ORIGINATION FORM

Proposed Revisions to a Standard Plans Index
(Please provide all information — Incomplete forms will be returned)

Index Number: 455-031
Sheet Number (s): 1 of 1
Index Title: 30" SQUARE PRESTRESSED CONCRETE PILE -
HIGH MOMENT CAPACITY

LAST REVISION 11/01/22	DESCRIPTION:		FY 2023-24 STANDARD PLANS	30" SQUARE PRESTRESSED CONCRETE PILE - HIGH MOMENT CAPACITY	INDEX 455-031	SHEET 1 of 1
---------------------------	--------------	--	-------------------------------------	---	-------------------------	------------------------

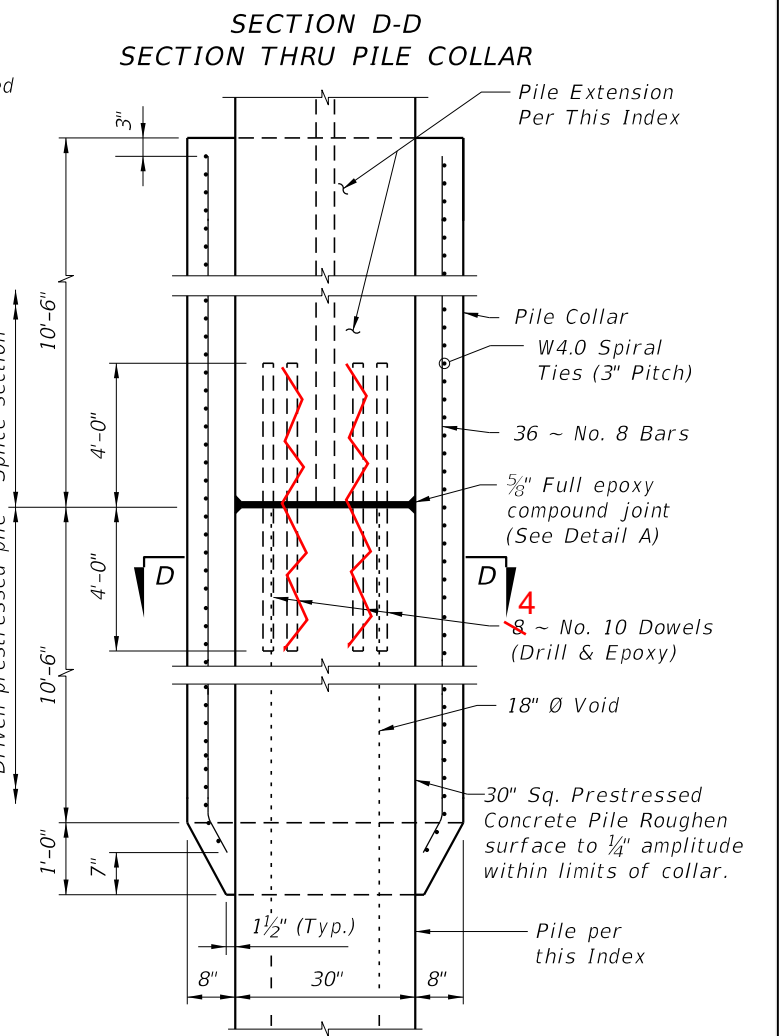
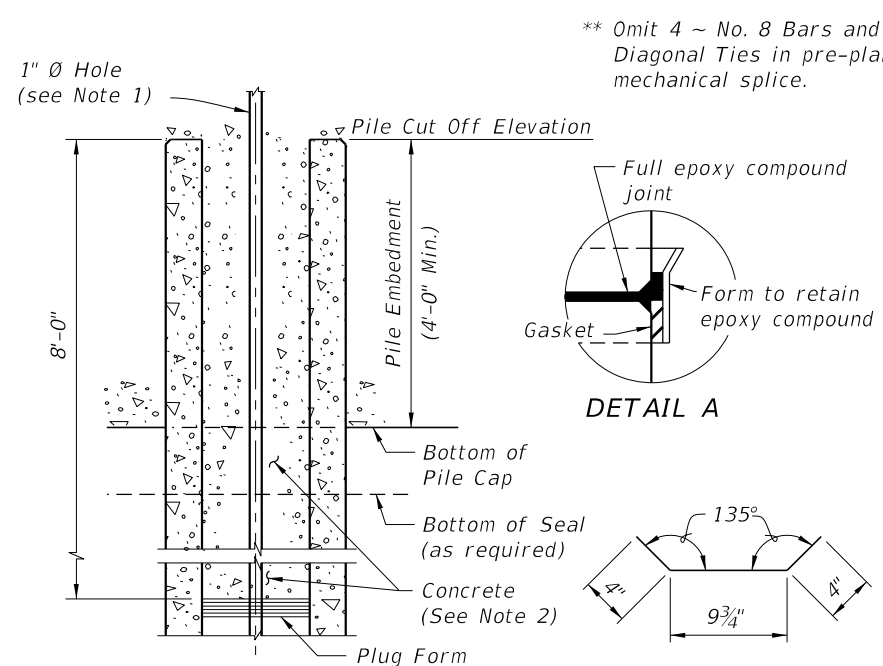
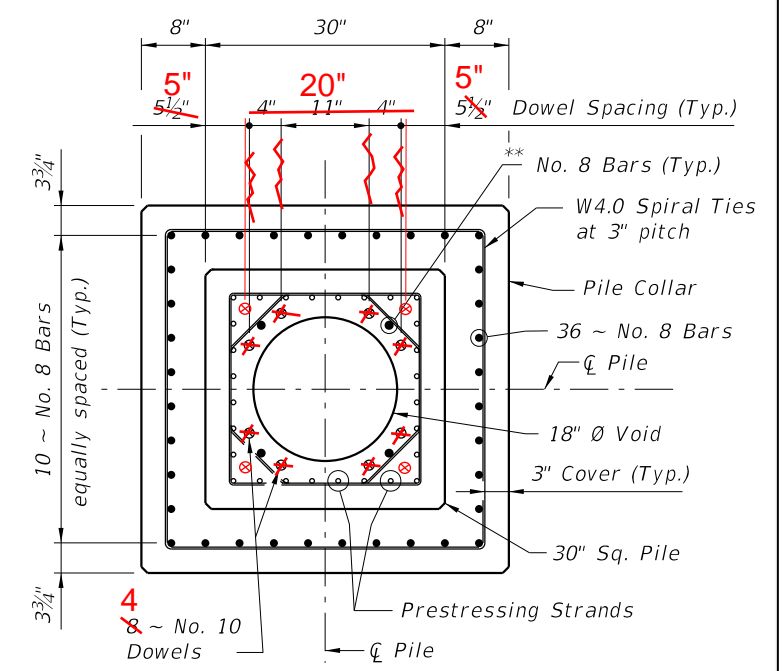
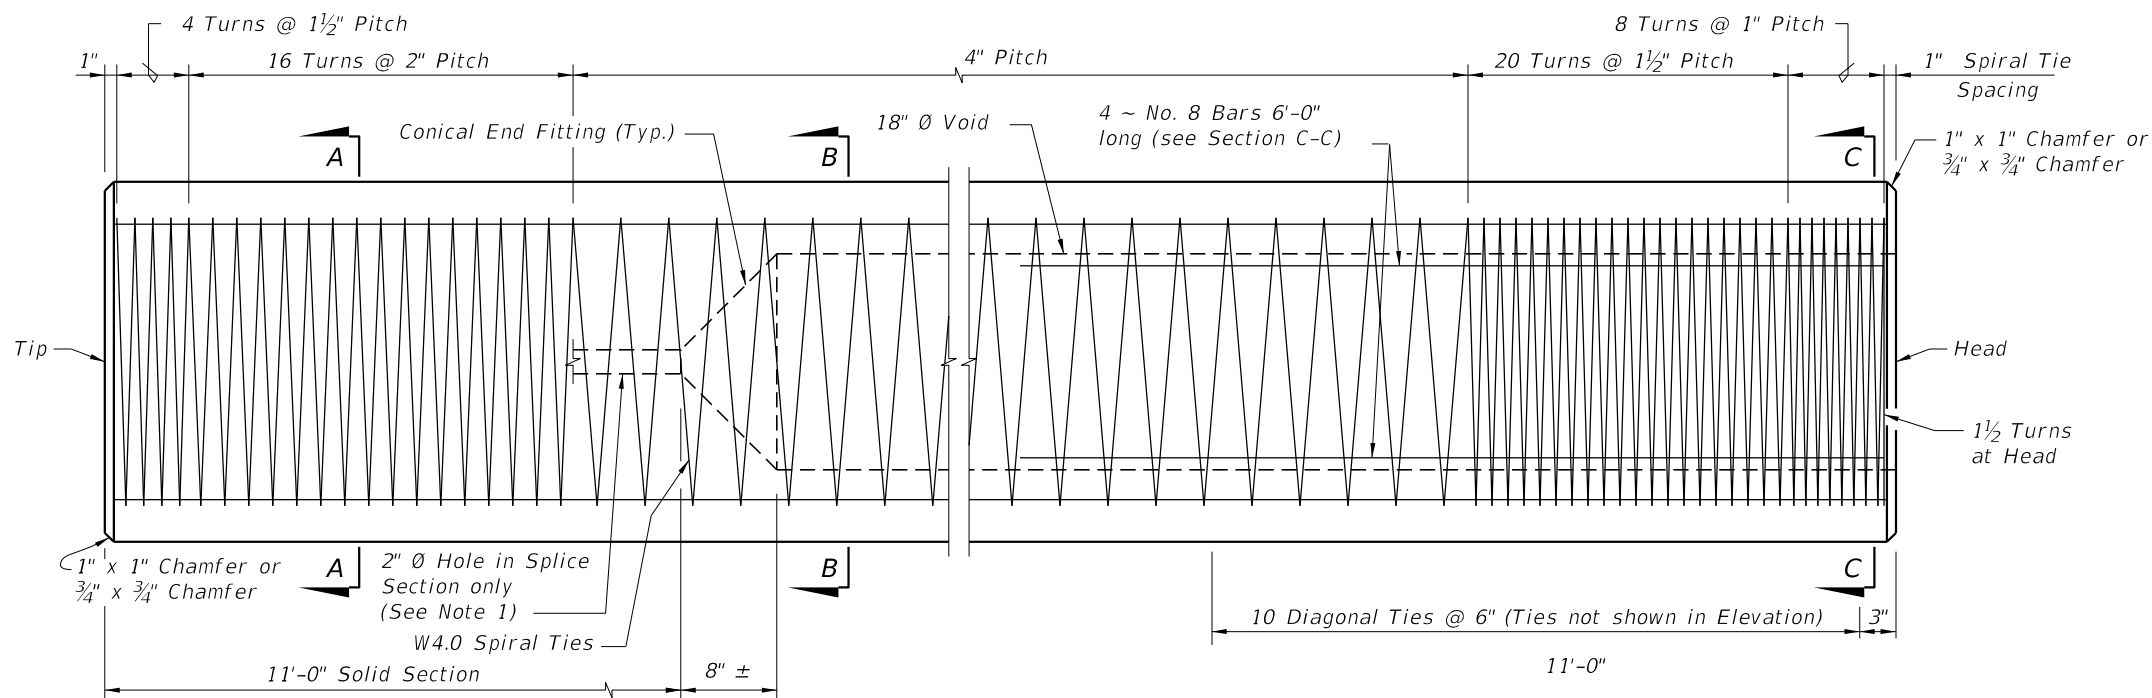
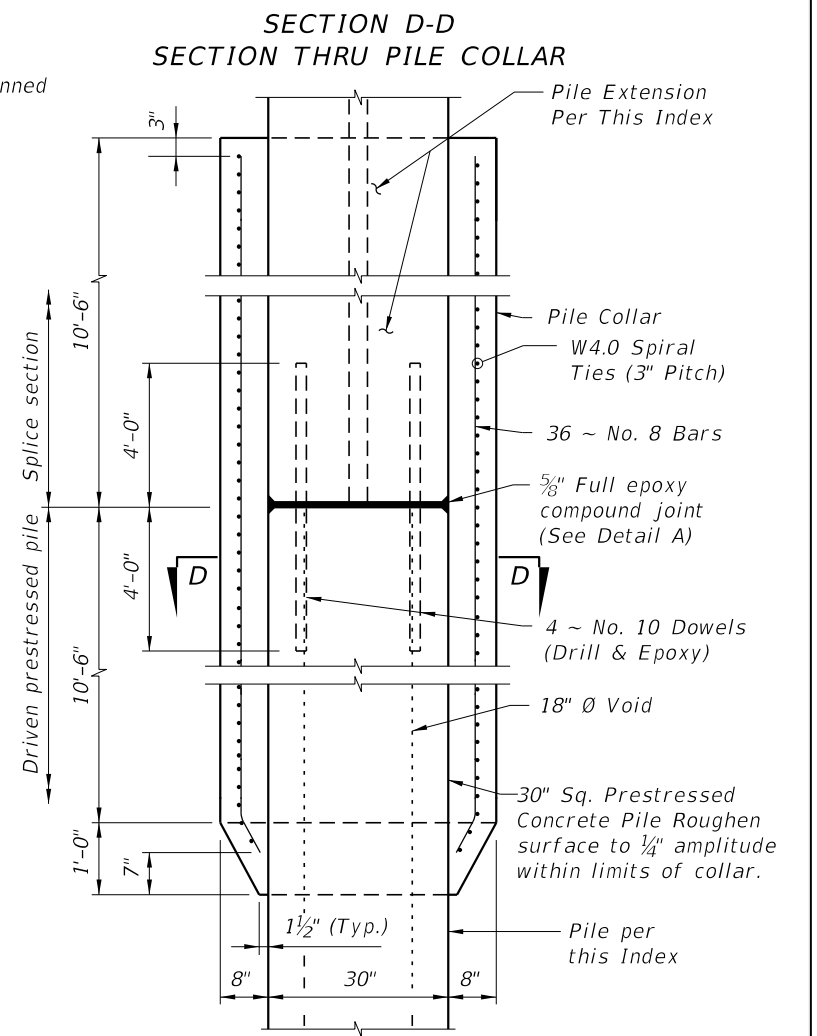
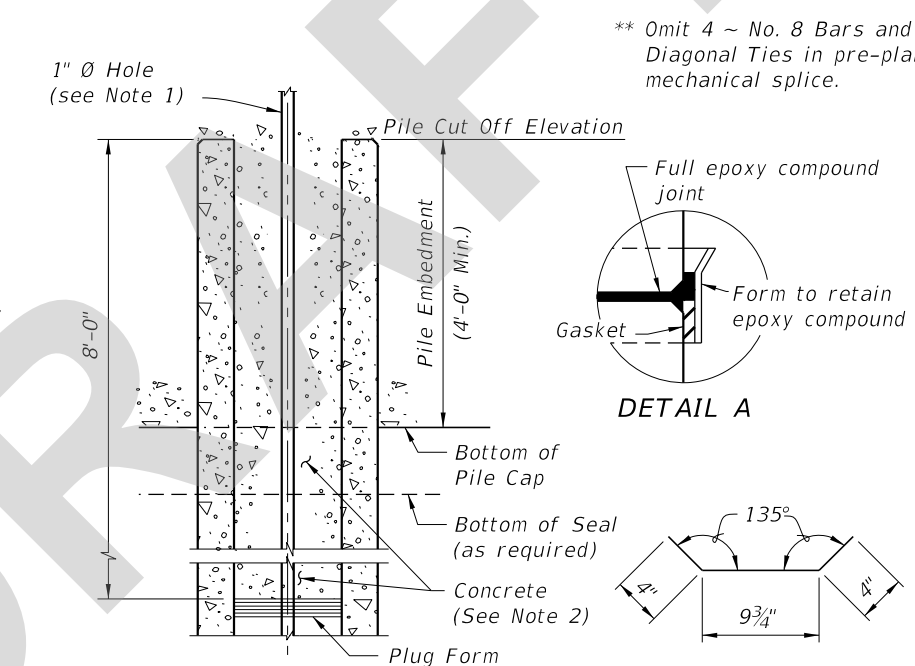
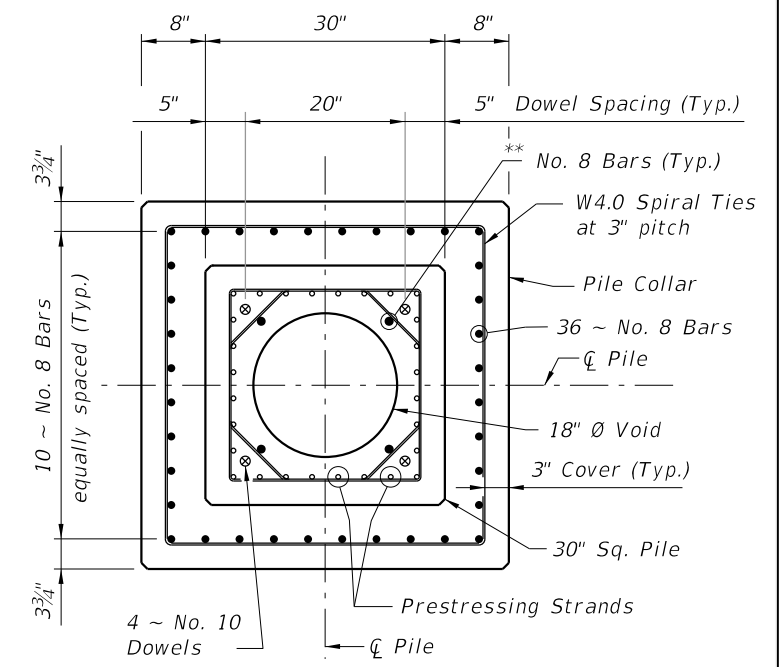
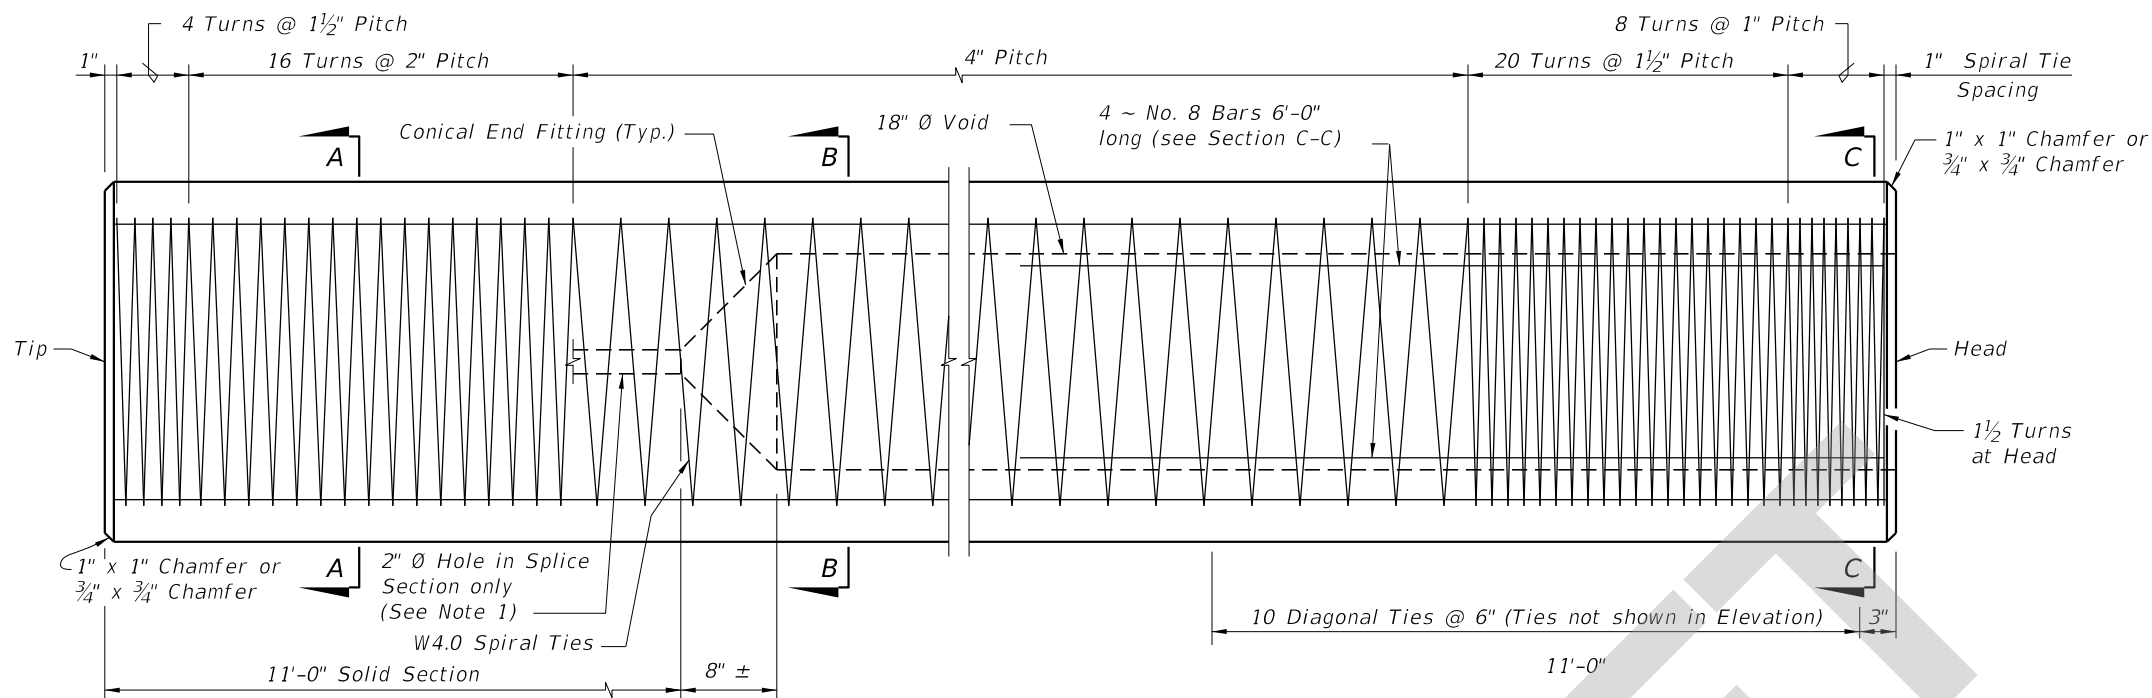
Sheet 1: Changed the location of the dowels; Deleted part of note 2 not allowing for corrugated galvanized metal pipe forms.

The location of drilled holes for the #10 dowels that are epoxied into the voided end for the splice connection are extremely close to the face of the void and will spall during drilling (1-3/4" drill bit).

These dowel bars should be moved further inside the pile wall, but the only place to avoid other reinforcing is inside the corner of the strand pattern (see the blue circle in the markup below). This would reduce the total number of dowel bars possible from 8 to 4, but this should be OK since almost all the moment capacity comes from the collar reinforcing (36~ #8 bars on the perimeter) recognized these extend lapped 10-feet either side of the splice joint while the #10 dowel bars only extend 4-feet and are temporary restraint and alignment while the exterior collar is constructed. -- Steve Nolan

For the metal pipe forms it was decided that the forms would create a corrosion risk and reduce the possible lifespan of the pile. Therefore, this allowance was removed.
